MODIFICATION REQUEST:
**Sydney Adventist Hospital Alterations
and Additions**
185 Fox Valley Road, Wahroonga
(MP10_0070 MOD 2)

- Modification to the building form of the Clinical Services Building, including an increase in GFA and height.
- Modification to the staging schedule of works.

Director-General's
Environmental Assessment Report
Section 75W of the
Environmental Planning and Assessment Act 1979

April 2012

Figure 13: MOD 2 Proposed CSB – South Elevation

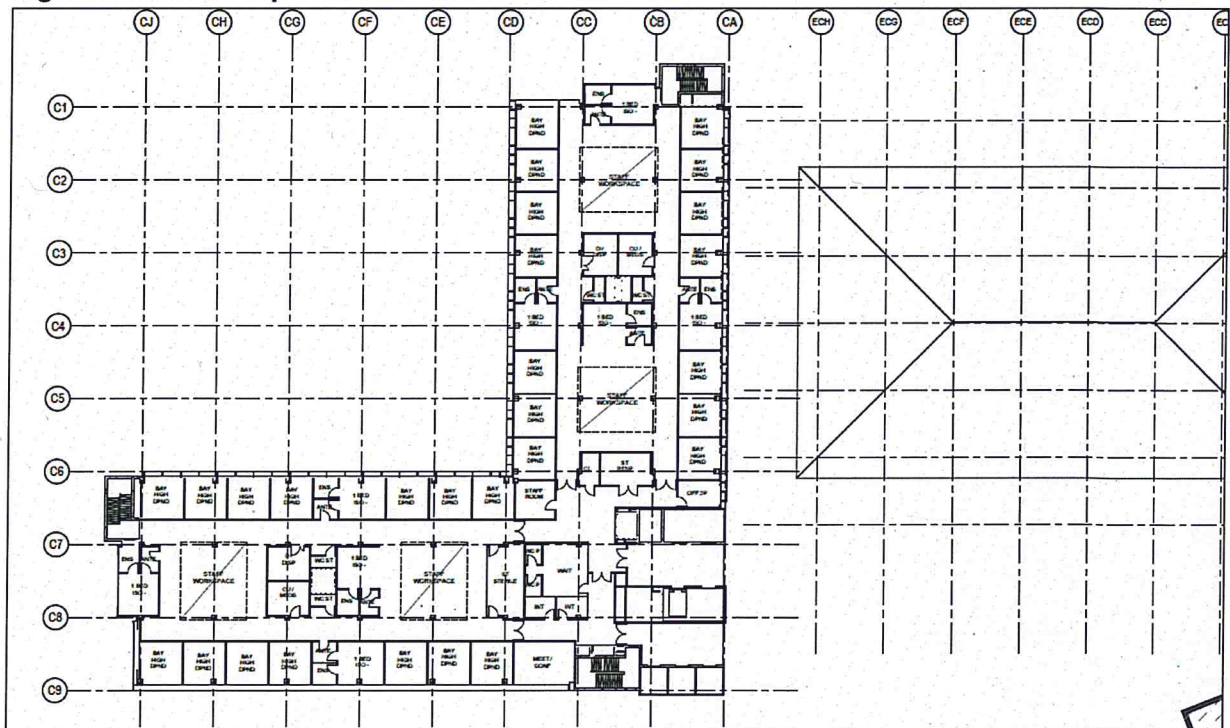
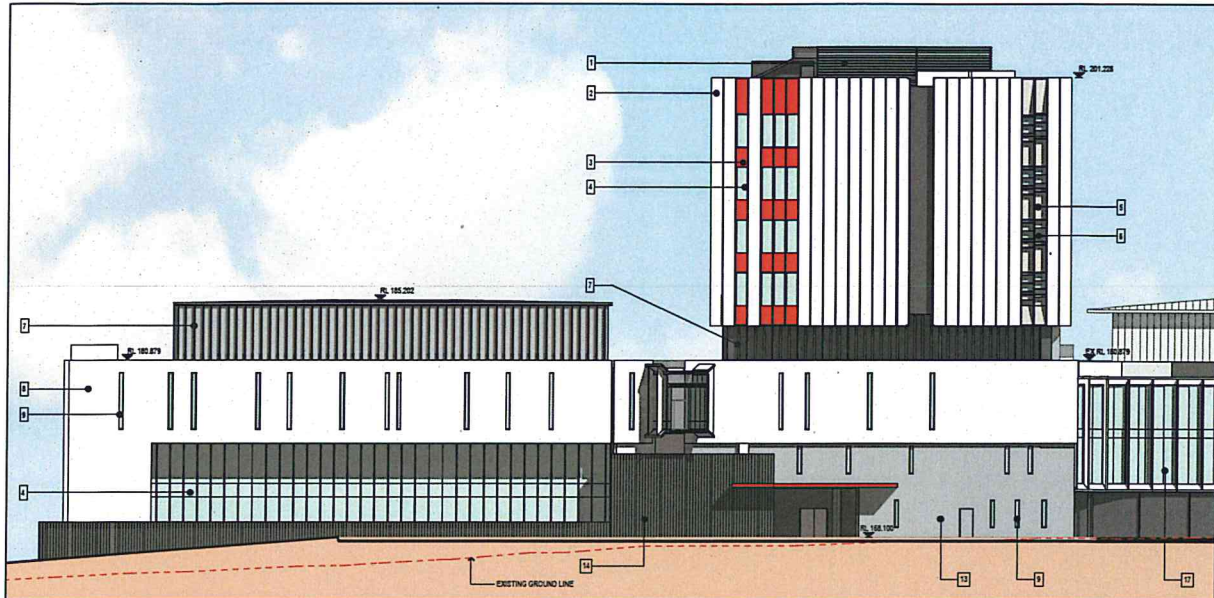
The proposed amended built form reduces the bulk of the lower five floors of the extension and provides improved linkages to the western side of the hospital precinct, via a more formalised access point on Level 2 and large landscaped courtyard that would provide improved amenity for both staff and patients. It is acknowledged, however, that the proposed amended 'L' shape tower form will generate additional building bulk, specifically from the western arm of the tower.

The additional bulk generated by the amended built form is visually represented within Figures 19 to 26 in Section 5.1.2 of this report. The comparative 'approved versus proposed' photomontages demonstrate that the proposed additional building bulk will create some visual impacts within the immediate locality along The Comenarra Parkway. However, these minor visual impacts would be restricted to The Comenarra Parkway between the intersection with Browns Road and Fox Valley Road, and would be further integrated into the site's redevelopment upon construction of the approved Shannon Building adjacent. Despite the greater visual prominence of the proposed amended built form immediately adjacent to its surrounds, the visual impact generated from a district perspective is considered minor and will not detrimentally impact on the visual qualities of the skyline.

In addition, the scale and massing of the amended built form is not out of character with the approved Shannon Building and existing Clifford Building, while any direct impacts of the development's built form are largely contained within the SAH hospital site. The façade of the amended built form expresses variations in both materials and finishes which generates greater interest in the built form and is similar in character to the approved Shannon Building adjacent.

The department considers the amended 'L' shaped built form of the CSB to be satisfactory in that it provides for improved functionality and operation within the hospital. The proposal would also provide for improved linkages to the western side of the hospital precinct and offer a new formalised landscaped area that will increase patient and staff amenity. The proposed scale and finishes of the amended CSB building is in keeping with the theme of clustering larger buildings towards the centre of the SAH precinct and will not be out of character with the adjacent approved Shannon Building.

Figure 17: CSB West Elevation - Extent of non-compliance

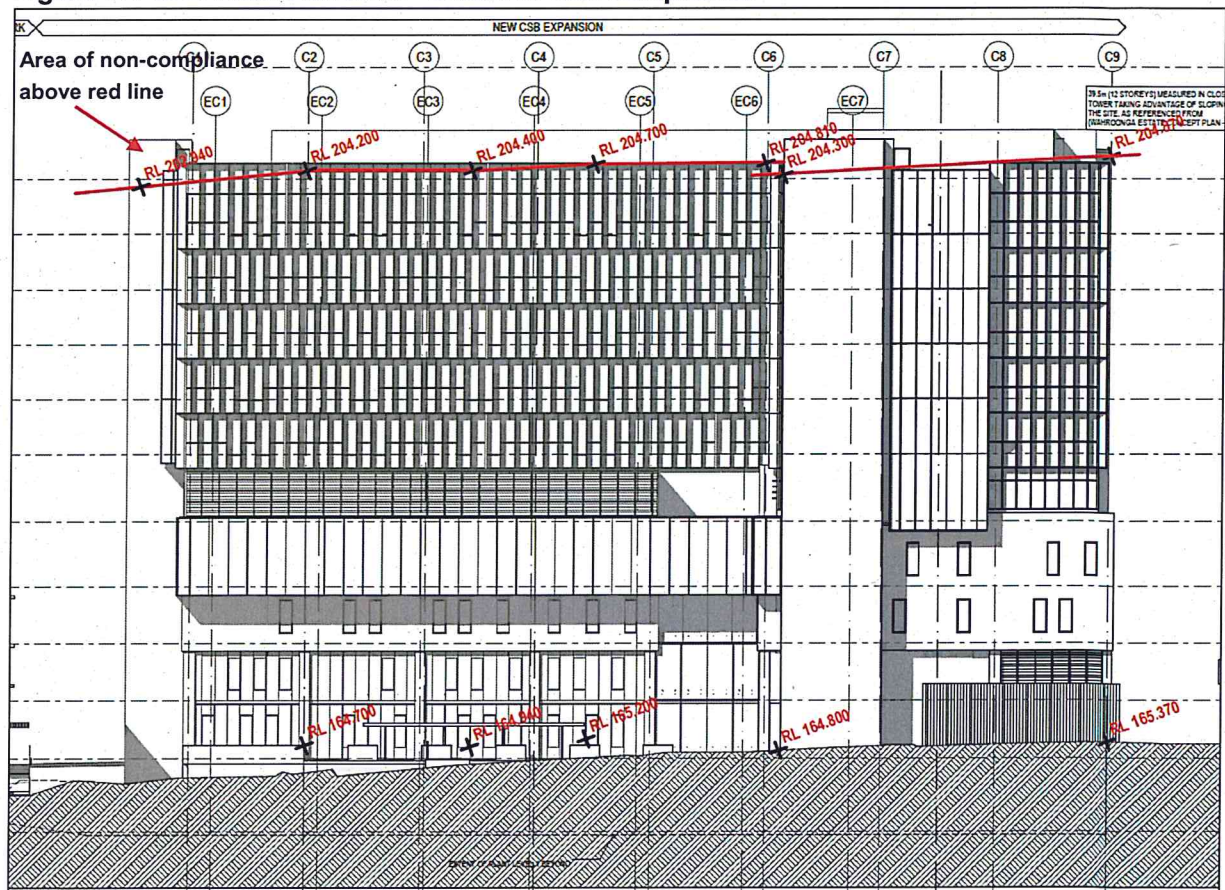
The CSB development site is characterised by undulating ground levels, with the site falling approximately 4 metres towards the west and northwest, away from the centre of the SAH hospital precinct. The extent of the undulating slope influences the level of non-compliance, with the ends of the southern and western wings of the amended design displaying the greatest areas of the non-compliance. The extent of the varying non-compliance is depicted by the building elements above the red line on the western and southern building elevations (see Figures 17 and 18).

The proponent notes that the additional building height is generated by the necessity for additional plant and storage space within the building design, with the plant and services on Level 13 and fire stairs located at the northern and western ends of the building located above the maximum height.

Figure 21: Approved South-Western Photomontage View – Comenarra Parkway, Wahroonga

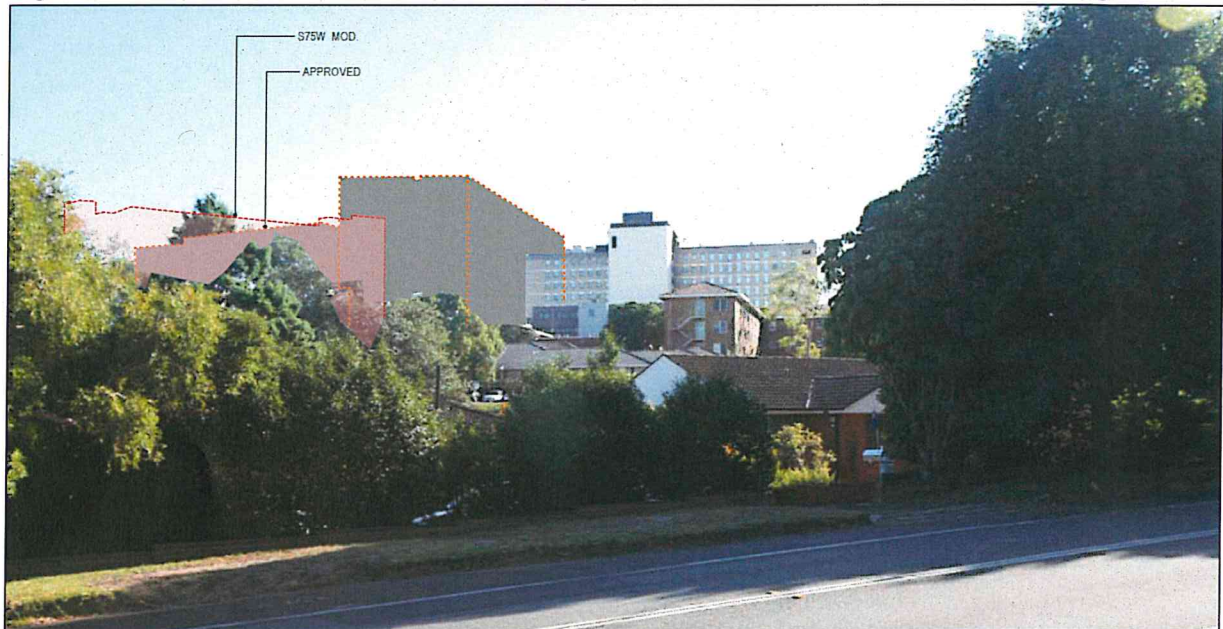
The visual prominence of the proposed amendments to the CSB design is most evident from The Comenarra Parkway, as depicted above. Notwithstanding this, it is the proposed amended design of the CSB rather than the proposed departure from the maximum building height control that generates the most notable change in the visual impact generated.

The siting of the CSB building within the centre of the hospital precinct and presence of the existing mature vegetation fronting The Comenarra Parkway will provide a level of visual relief and soften the immediate impact of the built form.
